BLOCK 16

DESIGN COMMISSION PACKAGE | 07/27/20

Date: June 26, 2020
To: City of Austin Design Commission
From: Planning & Urban Design Working Group
Subject: Downtown Density Bonus Program review of the Block 16 project for substantial compliance with the Urban Design Guidelines.
Meeting Date: June 19, 2020; 1:00 pm, Virtual Meeting (Microsoft Teams)
Applicant: Richard Suttle, Armbrust & Brown
Architect: Gensler

GROUND LEVEL FLOOR PLAN

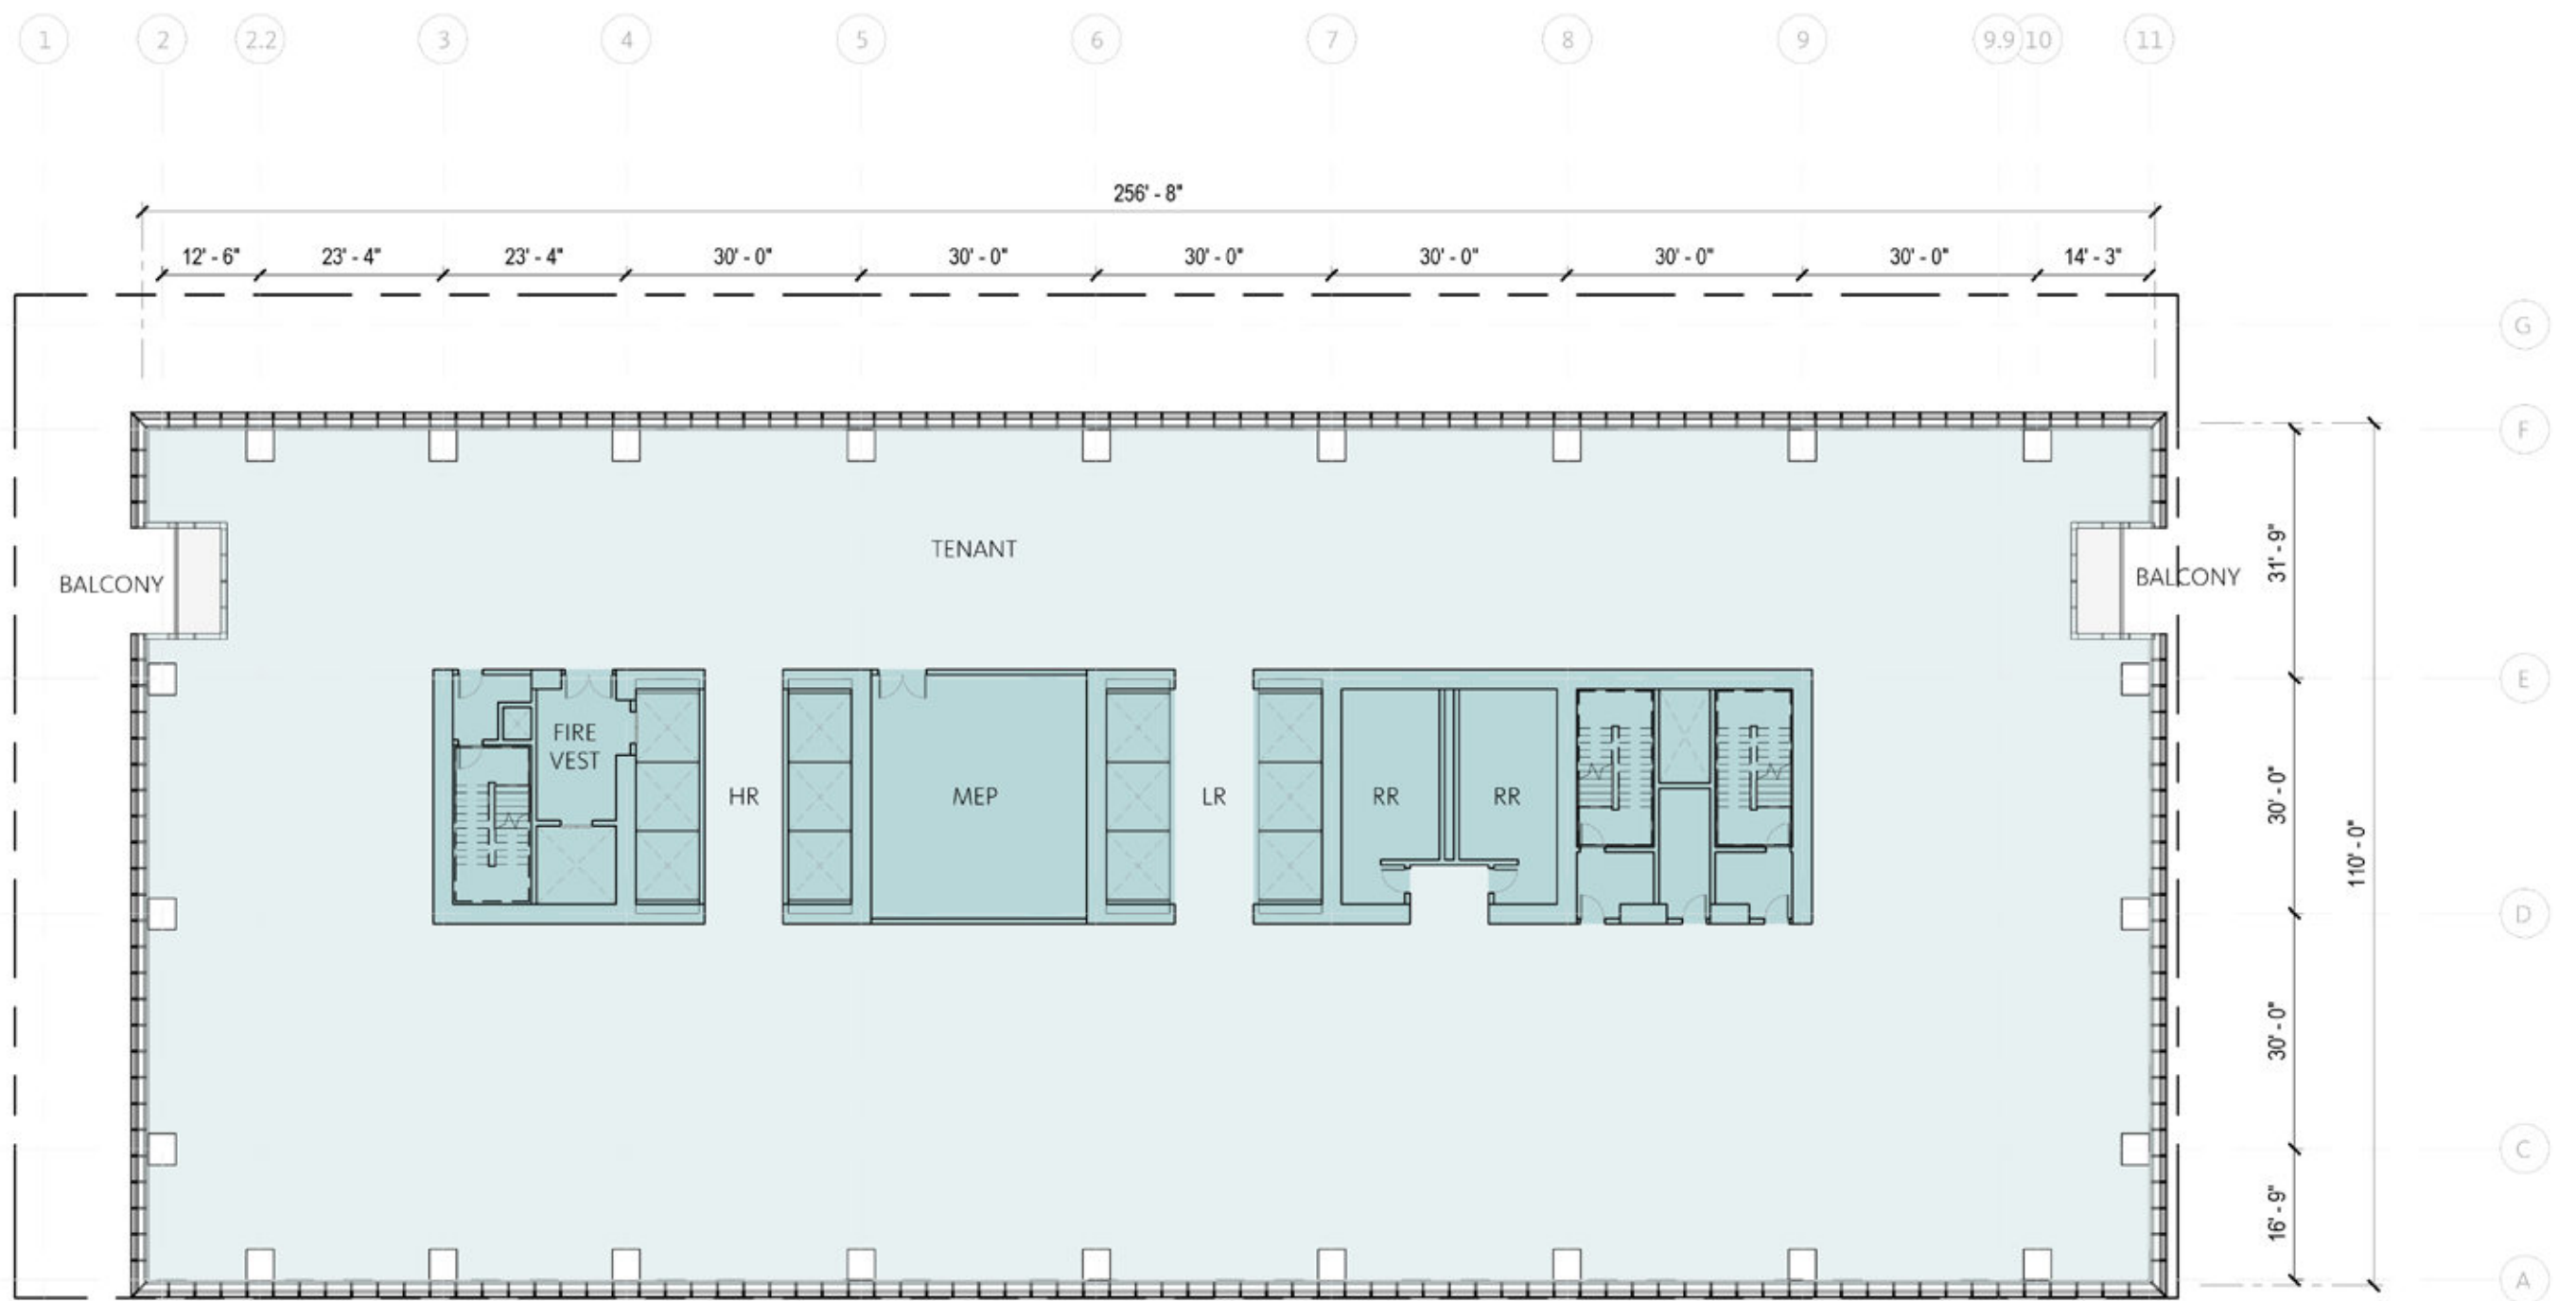
4. Reinforce Pedestrian Activity:
Great Streets compliance and proposed colonnade supports pedestrian circulation; however, a lack of pedestrian oriented uses on the first floor, along with an oversized unprogrammed lobby, does not help to enhance activity. Additionally, the existing wayfinding signage at 2nd and Trinity Streets appears to be removed in the proposed plan. Project does not comply. Encourage street vendors and preserve wayfinding to comply.

9. Provide Pedestrian-Scaled Lighting:
Street lights are indicated, but no pedestrian lighting is shown. Project does not comply. Provide pedestrian lighting to comply.

7. Determine Plaza Function, Size, and Activity:
Plazas seem unprogrammed and appear to serve the public art only. Project does not comply with this section.
Provide a better sense of how plazas will be used to comply with this section.

10. Provide an Appropriate Amount of Plaza Seating:
Very little seating is shown on plan. Benches provided are not in plaza area. Project does not comply. Provide more seating as well as a variety as outline in the UDG.

12. Use Plants to Enliven Urban Spaces:
Other than what appears to be grass at public art there are no plants shown on drawings. Project does not comply. Provide planting plan to illustrate compliance.

14. Provide Food Service for Plaza Participants:
No food service is being shown. Project does not comply with this section. Illustrate how food kiosks can be integrated into the plazas and not interrupt pedestrian traffic to comply

VIEW FROM SOUTHEAST

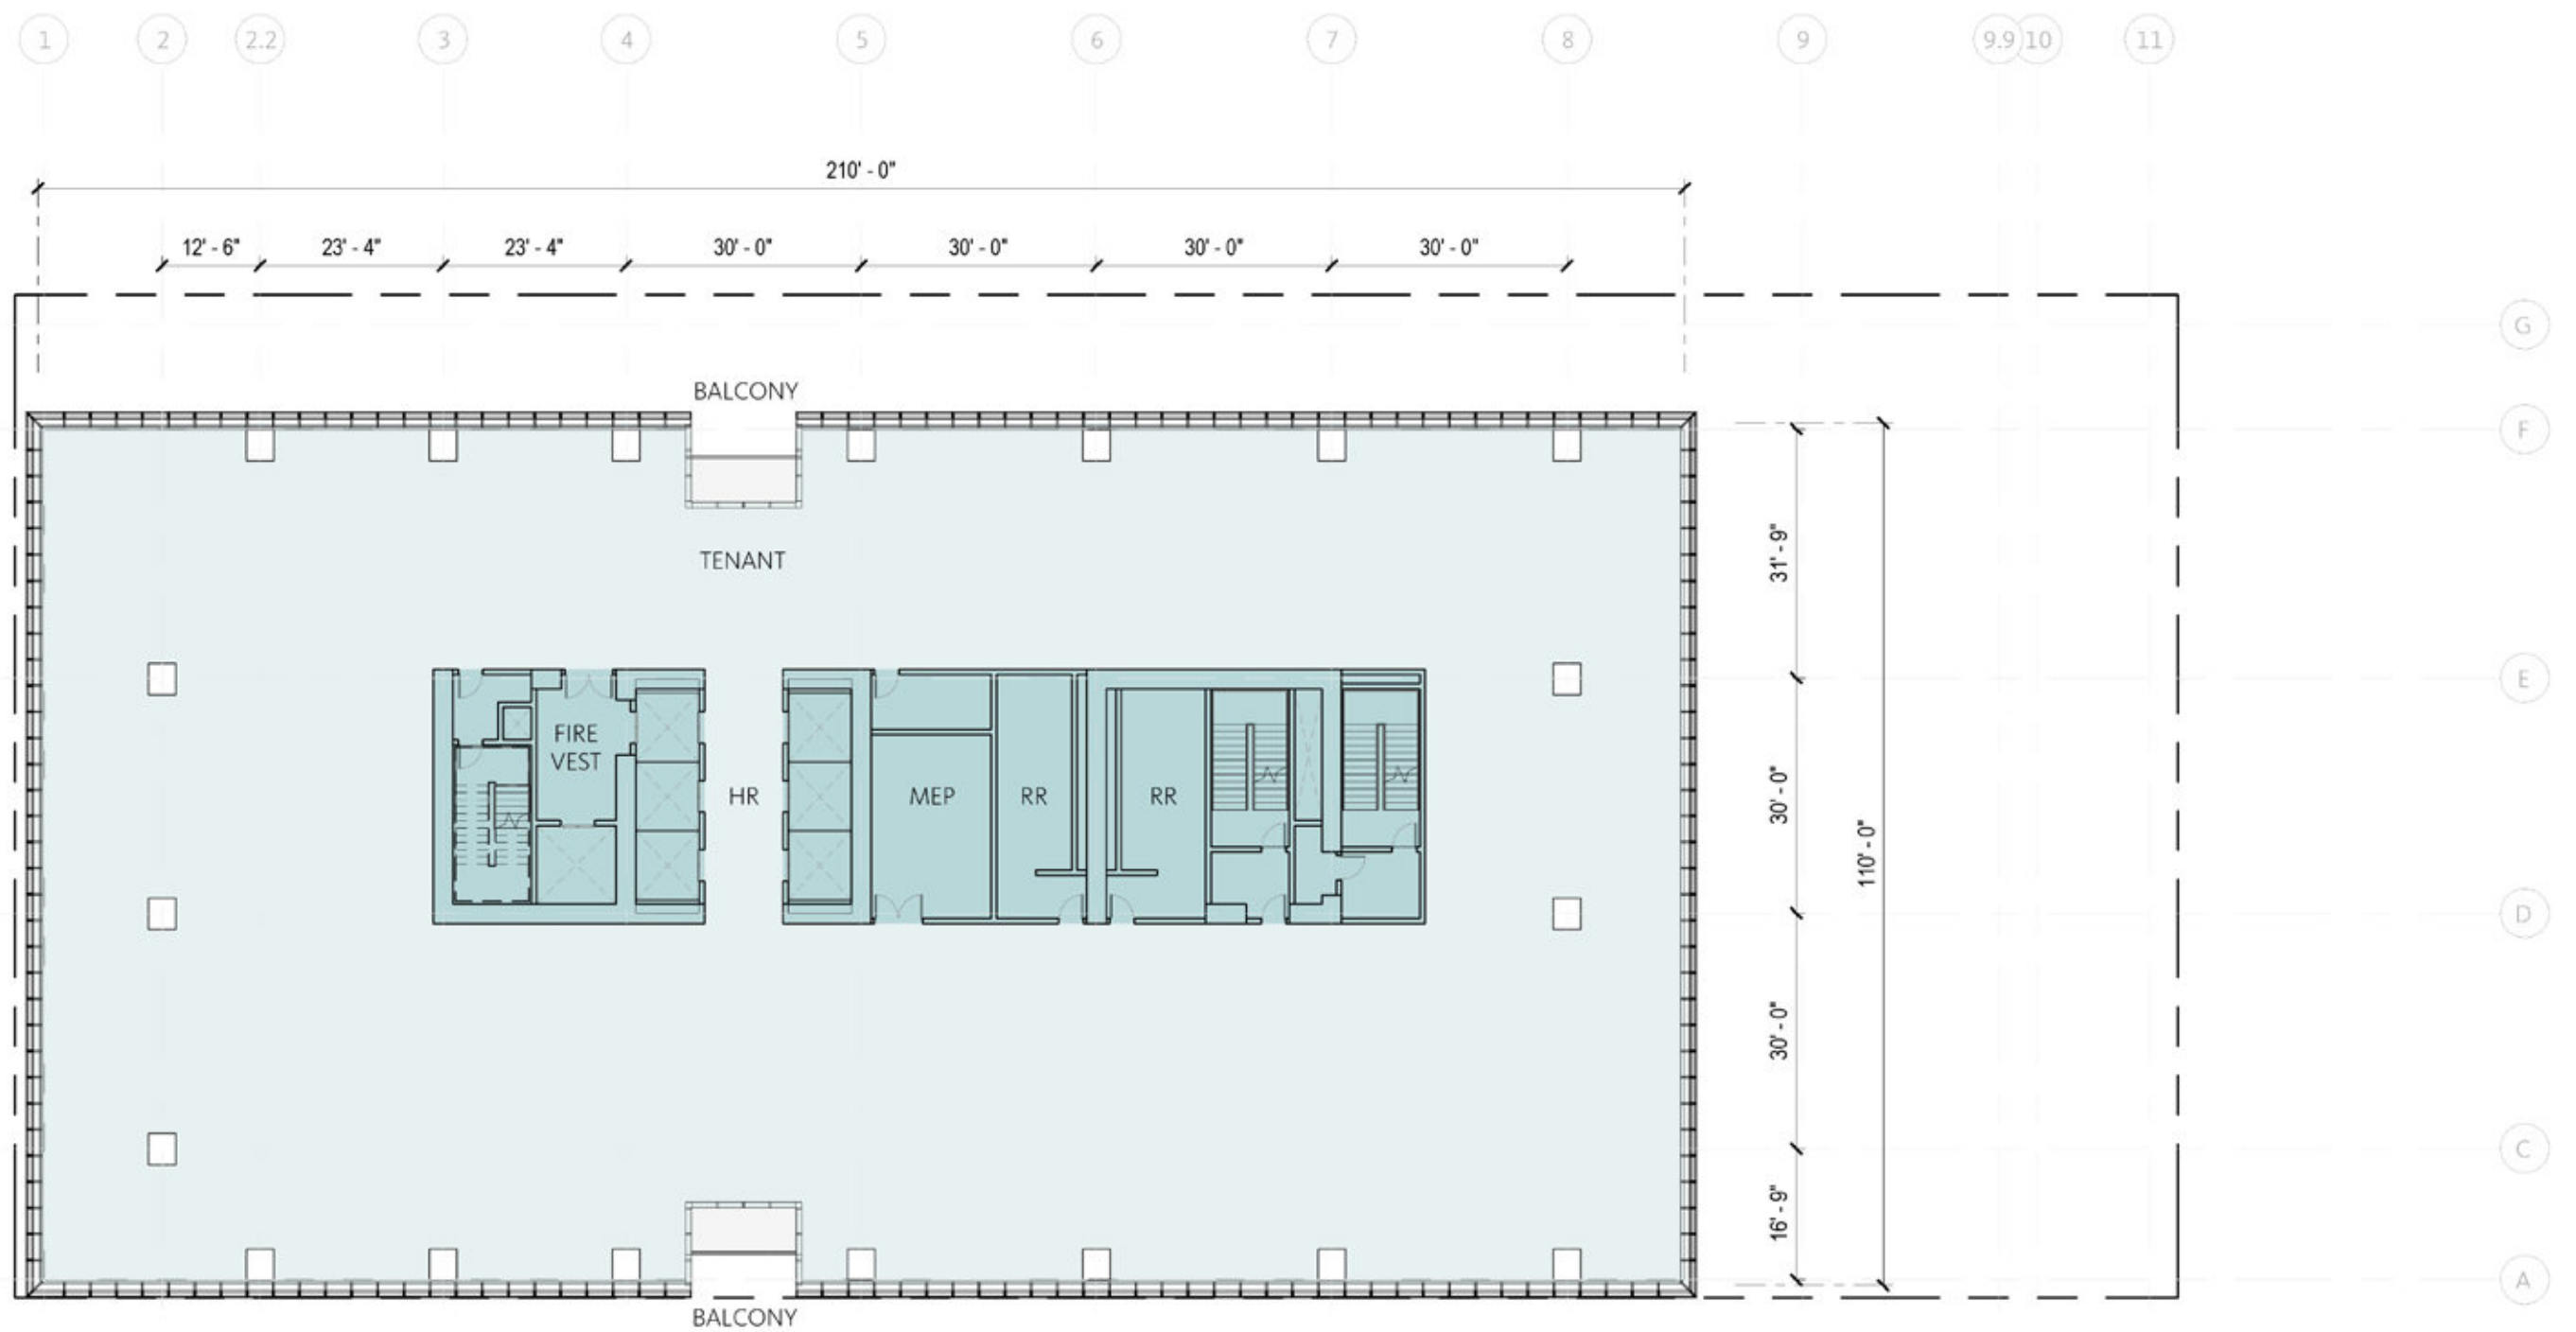
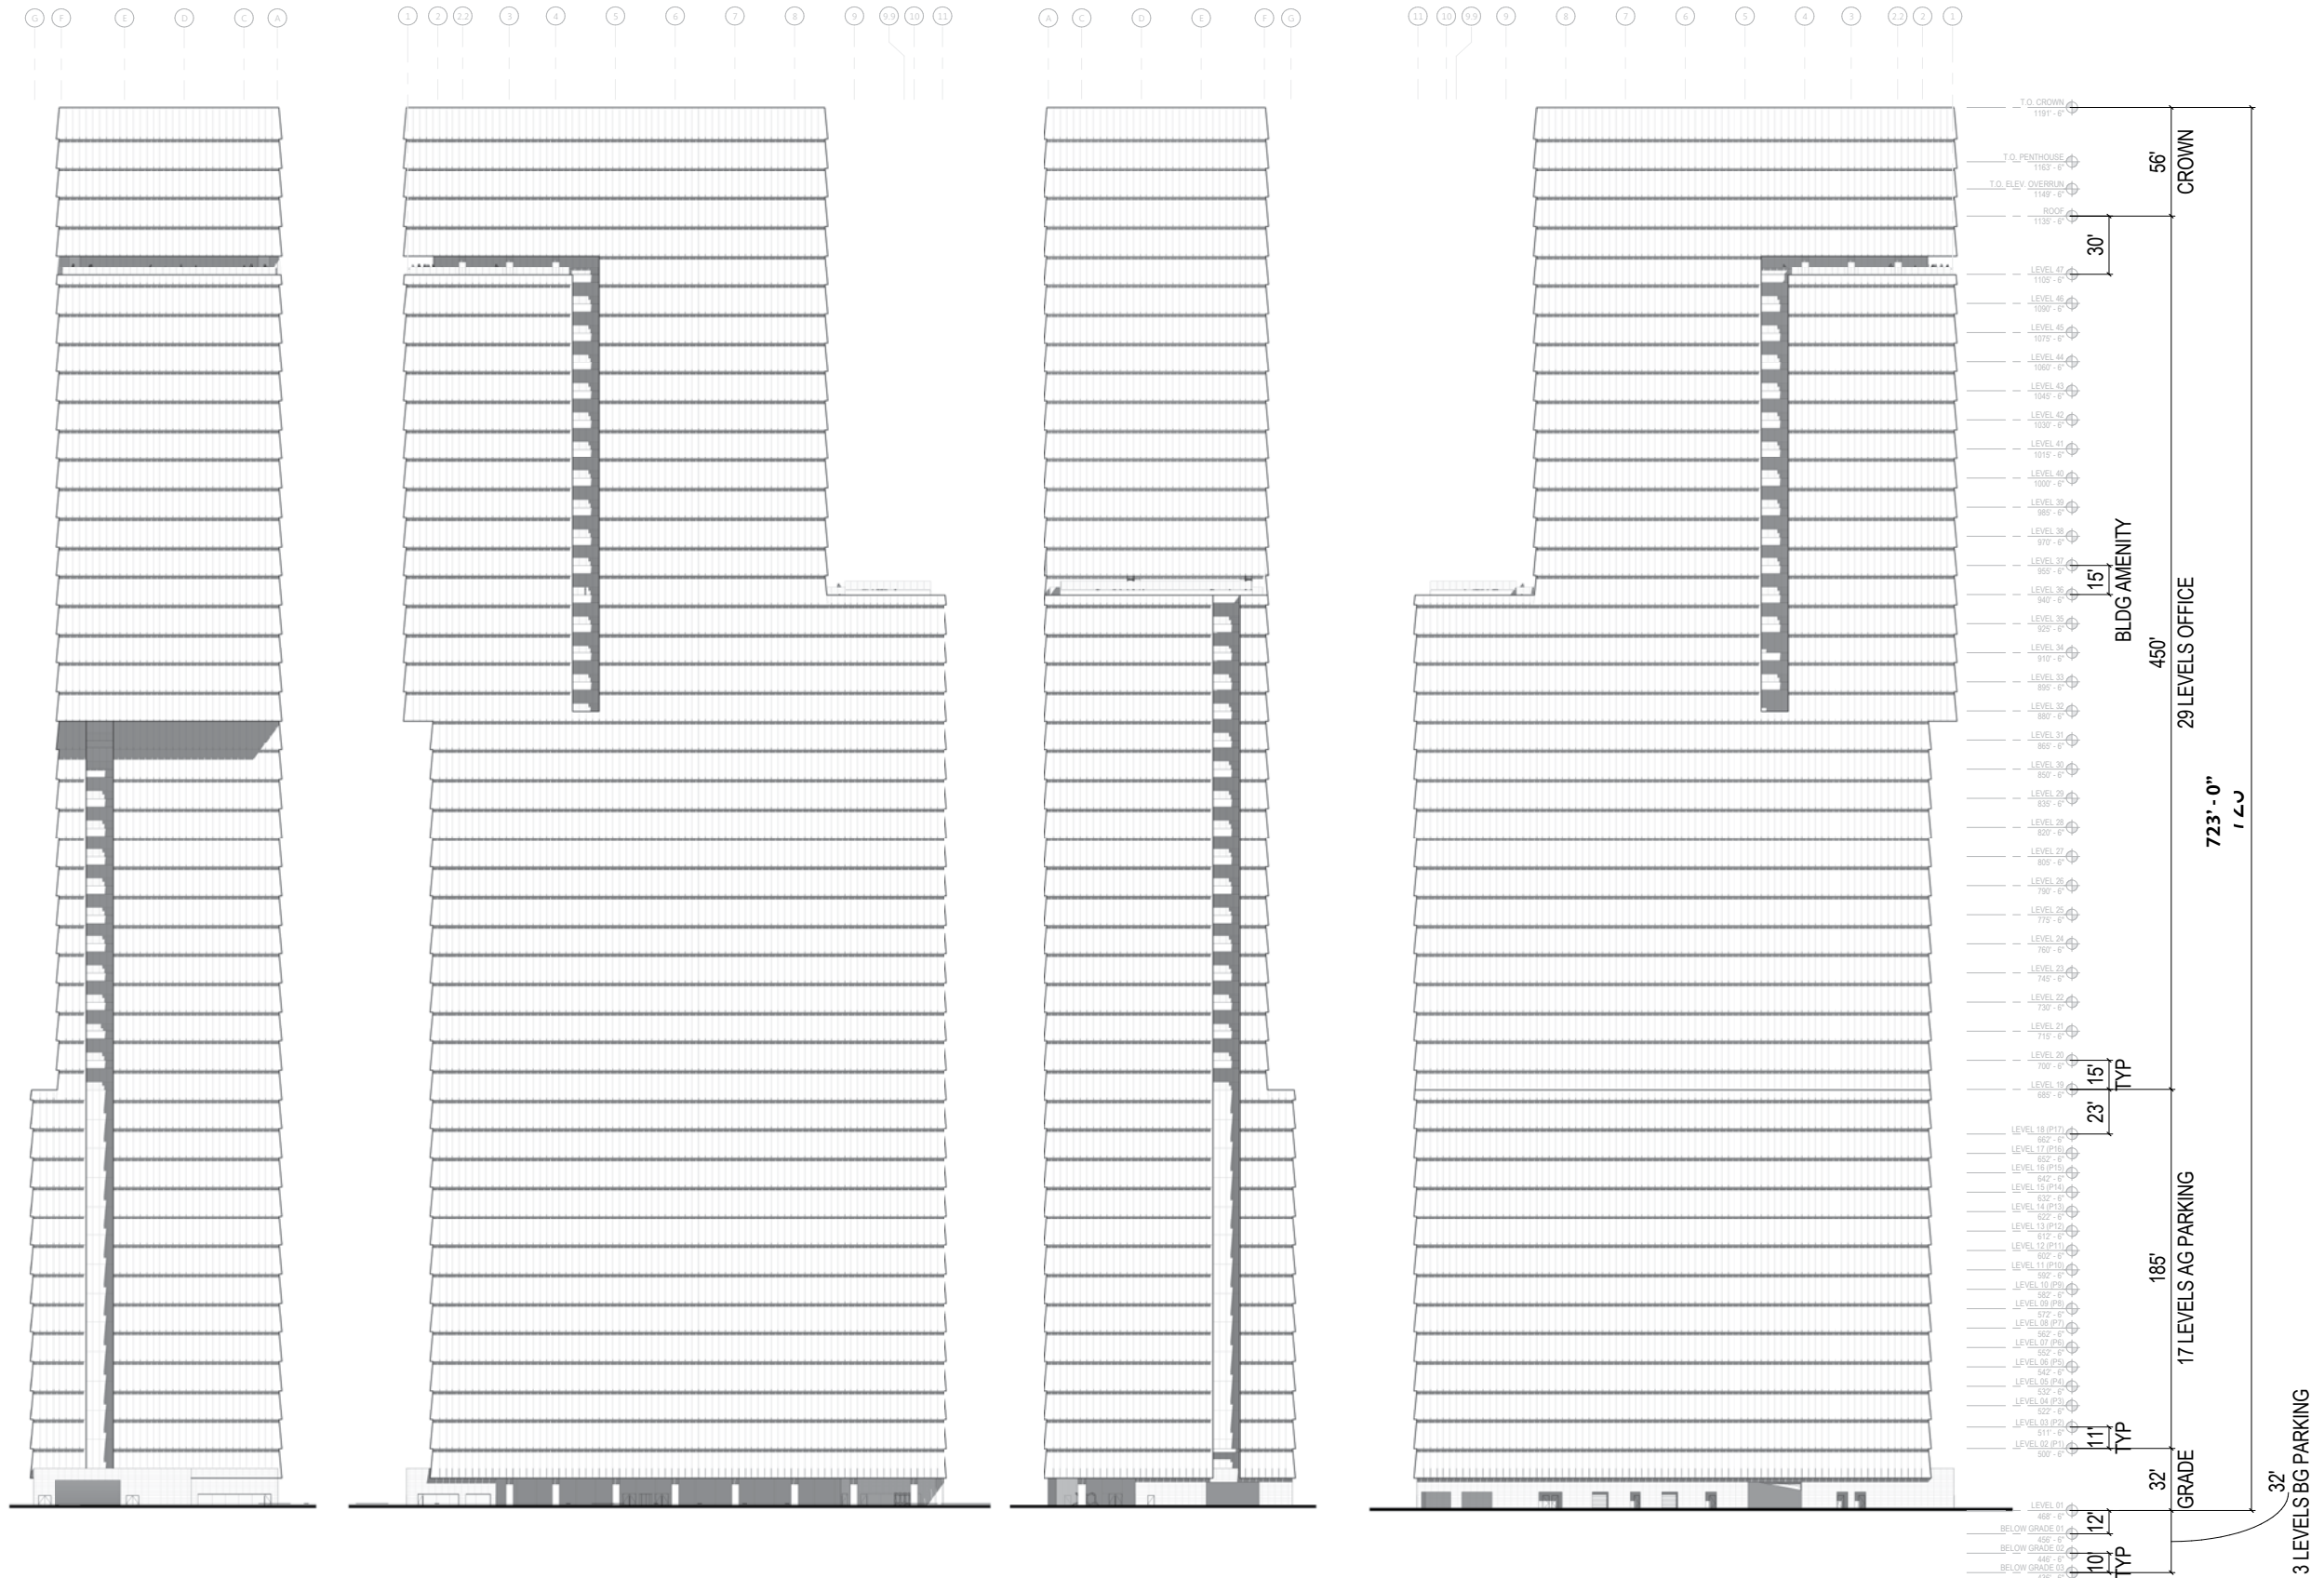
Street level materials appear to be large glass panels and marble or granite cladding, which is very cold. It is unclear what the proposed bench construction is. These are durable, but not pedestrian friendly. Project does not comply. Provide some warmer/softer materials to comply.

3. Accentuate primary entrances:
There is not discernable difference between entrances. Project does not comply. Accentuate entrances to comply.
4. Encourage the inclusion of local character:
The materials and articulation of the building in both form and detail is beautiful; however, it does not seem to contextually draw from any other structures or local materials. Project does not comply. Provide local character as outlined in the UDG to comply.

7. Create buildings with human scale:
Street level is double-height, with large panes of glass and large marble columns. Project does not comply. Provide more variety of scales to comply.
